7.2 Reactor Protection (Trip) System (RPS)—Instrumentation and Controls

The information in this section of the reference ABWR DCD, including all subsections, tables and figures, is incorporated by reference with the following departures and supplements.

STD DEP T1 2.3-1 (Table 7.2-1, 7.2-2, Figures 7.2-2, 7.2-6, 7.2-9, 7.2-10)

STD DEP T1 3.4-1 (Figures 7.2-2, 7.2-9, 7.2-10)

Figure 7.2-2 Reactor Protection System Equipment Arrangement (From Sensors Through Trip Actuators)

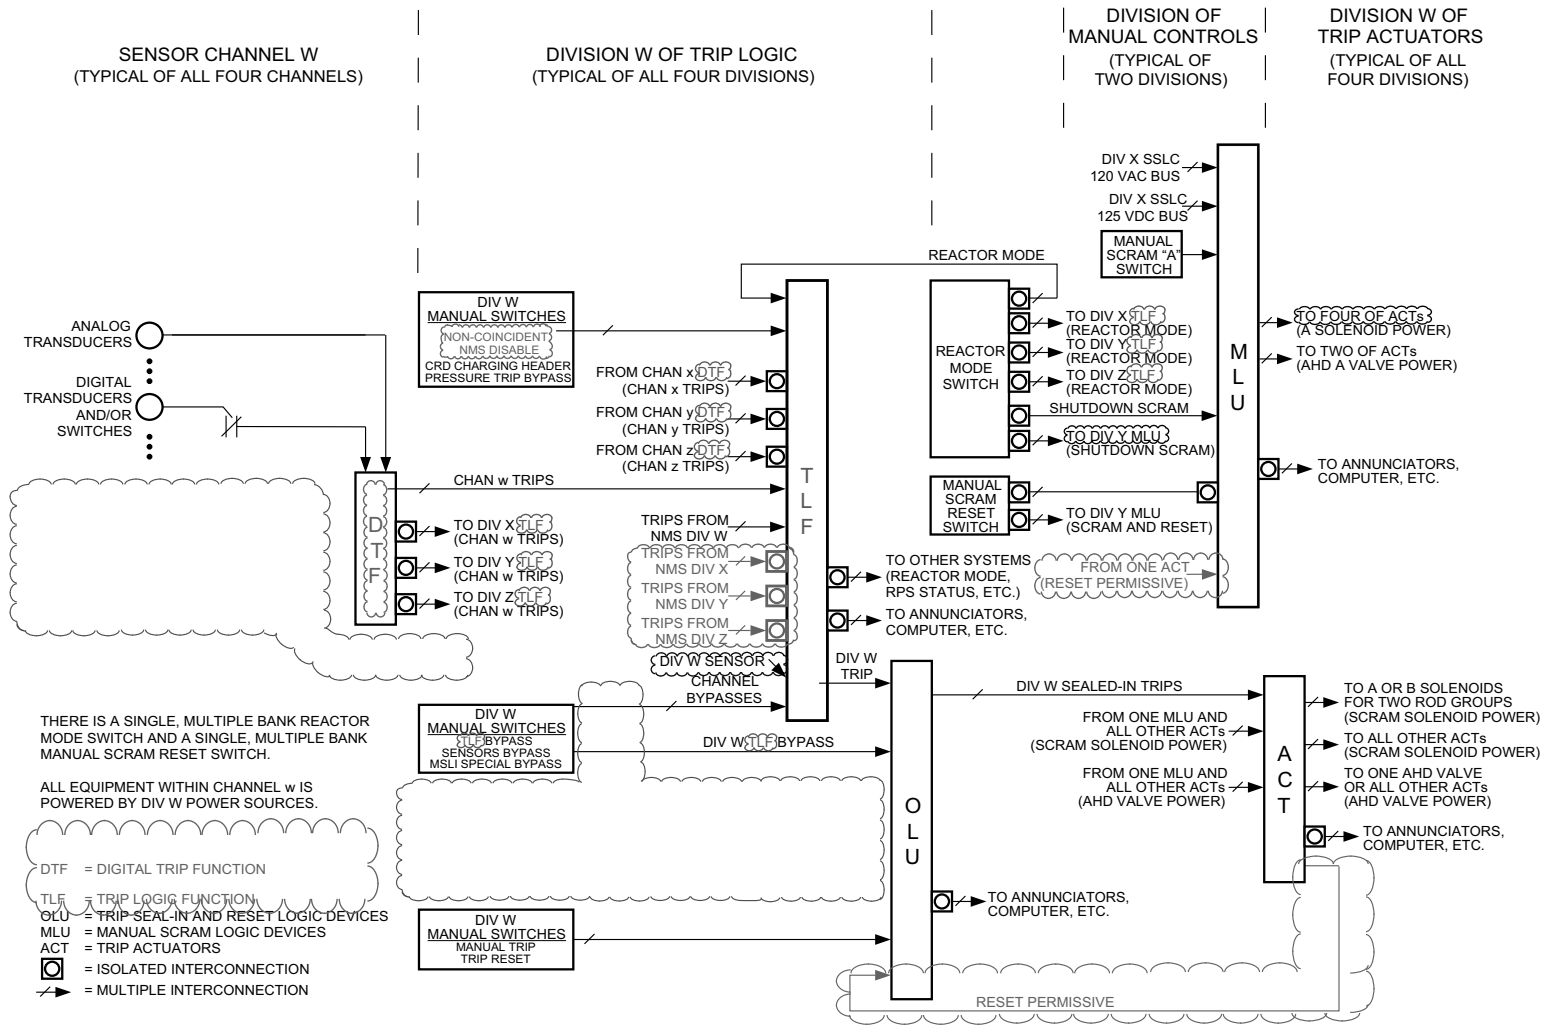
The RPS equipment is divided into four redundant divisions of sensor (instrument) channels, trip logics and trip actuators, and two divisions of manual scram controls and scram logic circuitry. The sensor channels, divisions of trip logics, divisions of trip actuators and associated portions of the divisions of scram logic circuitry together constitute the RPS scram and air header dump (backup scram) automatic initiation logic. The divisions of manual scram controls and associated portions of the divisions of scram logic circuitry together constitute the RPS scram and air header dump manual initiation logic. The automatic and manual scram initiation logics are independent of each other. RPS equipment arrangement is shown in Figure 7.2-2.

Four independent sensor channels monitor the various process variables listed in Subsection 7.2.1.1.4.2. The redundant sensor devices are separated so that no single failure can prevent a scram. The arrangement of RPS sensors mounted in local racks is shown in Figure 7.2-2. Locations for local RPS racks and panels are shown on the instrument location drawings provided in Section 1.7. ~~Divisional separation is also applied to the Essential Multiplexing System (EMS) D which provides data highways for the sensor input to the logic units. Physically separated cabinets are provided for the four scram logics. Fiber optic cable routing from remote multiplexing units (RMUs) remote digital logic controllers to control room equipment is shown in raceway plans provided by reference in Section 1.7. The criteria for separation of sensing lines and sensors are discussed in Section 7.1.~~

Figure 7.2-6 Division 1 Trip Logic

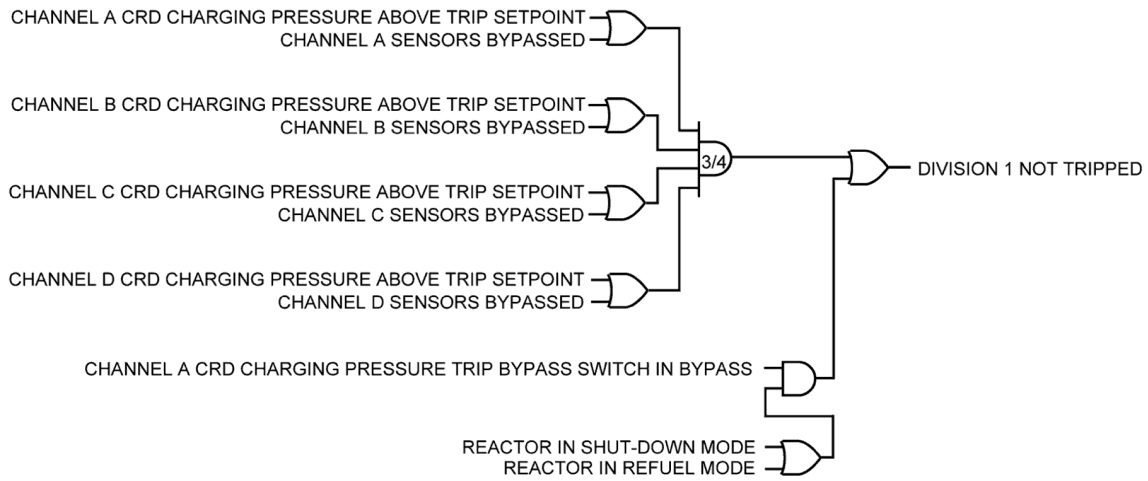
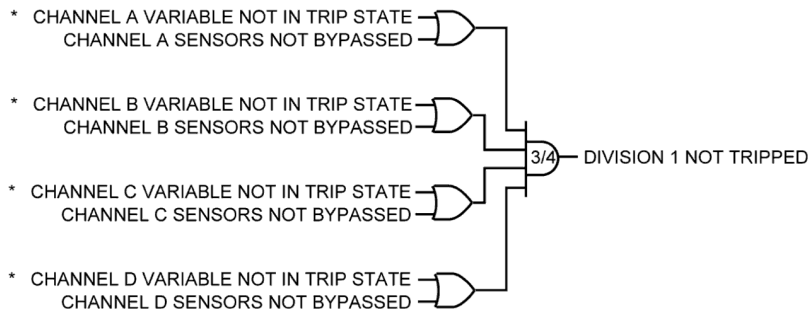
(2) Nuclear Boiler System (NBS) (Figure 7.2-6)

(3) Control Rod Drive (CRD) System (Figure 7.2-6)

(4) ~~Process Radiation Monitoring (PRM) System (Figure 7.2-6) Not Used~~
